June 22, 1984

This is in response to the Safety Evaluation Report (SER) dated April 30, 1984 (Log No. 1503) which addressed the proposed modifications to the Toledo Edison's Davis-Besse Nuclear Power Station, Unit 1, Reactor Trip System. These modifications were developed in response to the Required Actions Based on Generic Implications of Salem ATWS Event (Generic Letter 83-28, Log No. 1322 dated July 8, 1983).

REACTOR TRIP BREAKER
SHUNT TRIP CIRCUIT MODIFICATION
DAVIS-BESSE UNIT NO. 1

REACTOR TRIP BREAKER
ARRANGEMENT

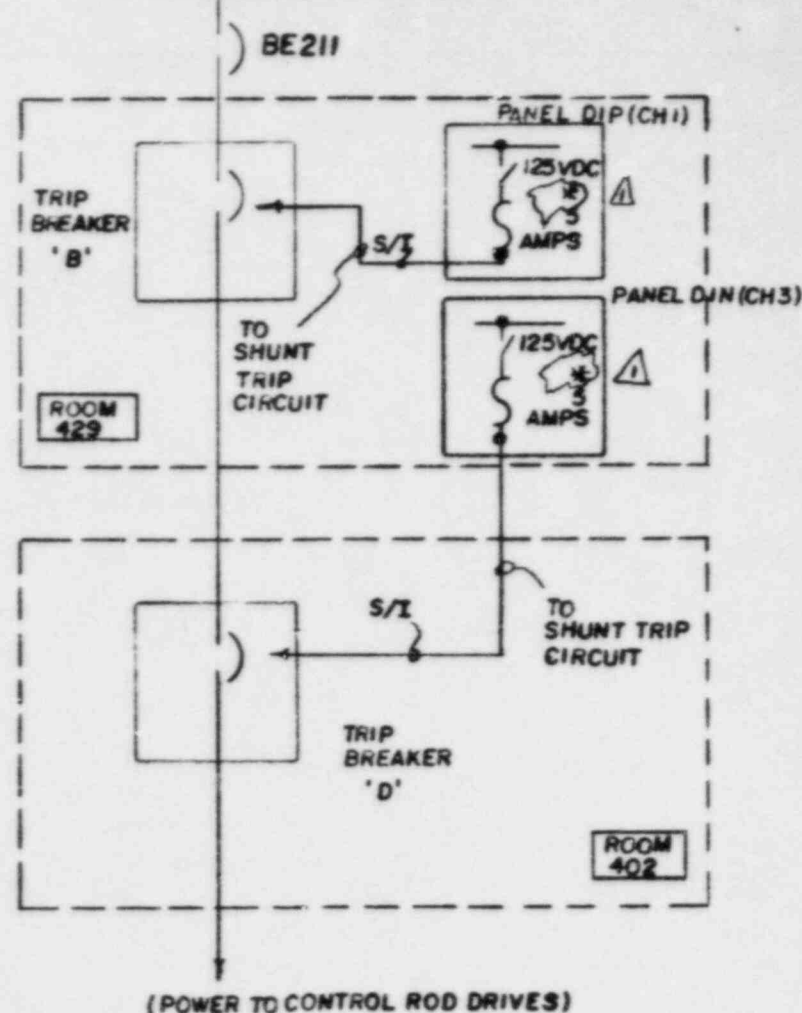
Power Supply
(Sketch No. 26372-1)

Power to shunt trip attachment of each reactor trip breaker (RTB) will be provided from a separate Class 1E power source. The cable carrying the control power will be Class 1E qualified and the associated conduit run will be installed to Seismic I category.

Control power to the non-safety related source interruption device (SID) will remain from the existing non-safety related 125 VDC source. Isolation between the non-safety related and the safety related wiring has been provided within the breakers and the cable routing outside the breakers.

Revised electrical schematics Nos. 26370-2, 26371-2 and 26372-1 are attached to this letter.

SCHEMATIC DIAGRAM
REACTOR TRIP CIRCUIT BREAKER

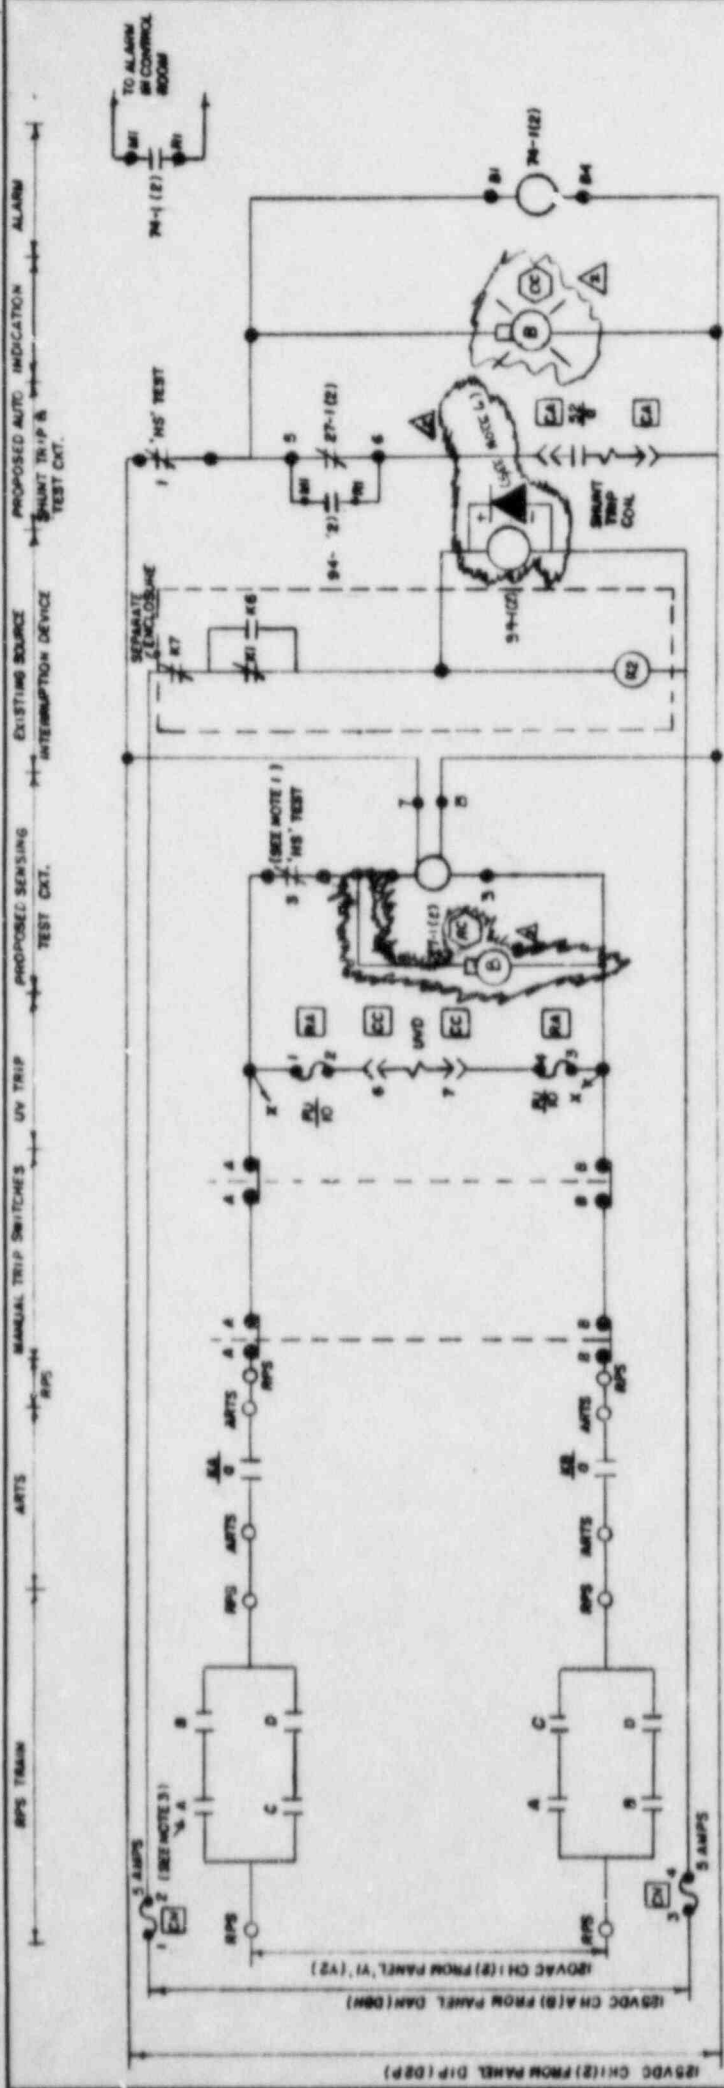
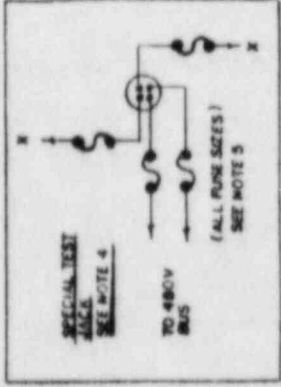
In the modified design the Model ITE-27H-211R relay, operable from a Class IE 125 VDC power source, is used to actuate the shunt trip attachment.

In the modified design, the shunt trip attachments will be designated as safety related. The shunt trip attachments in all four breakers will be seismically qualified, based on the qualification testing of similar attachments in AK-2 breakers of Unit Electric Control, Inc. We will assure that the test results in this report are acceptable according to the industry standards and applicable to the RTBs at DBNPS Unit No. 1.

Two indicating lights are provided in the modified design. One will be lit when power is available for the shunt trip attachment, and the second will be lit when power is available for the under voltage sensor.

Isolation of non-safety related SID from the 1E shunt trip will be provided through the coil to contact isolation of a Class 1E relay (94). (see drawing 26370-2)
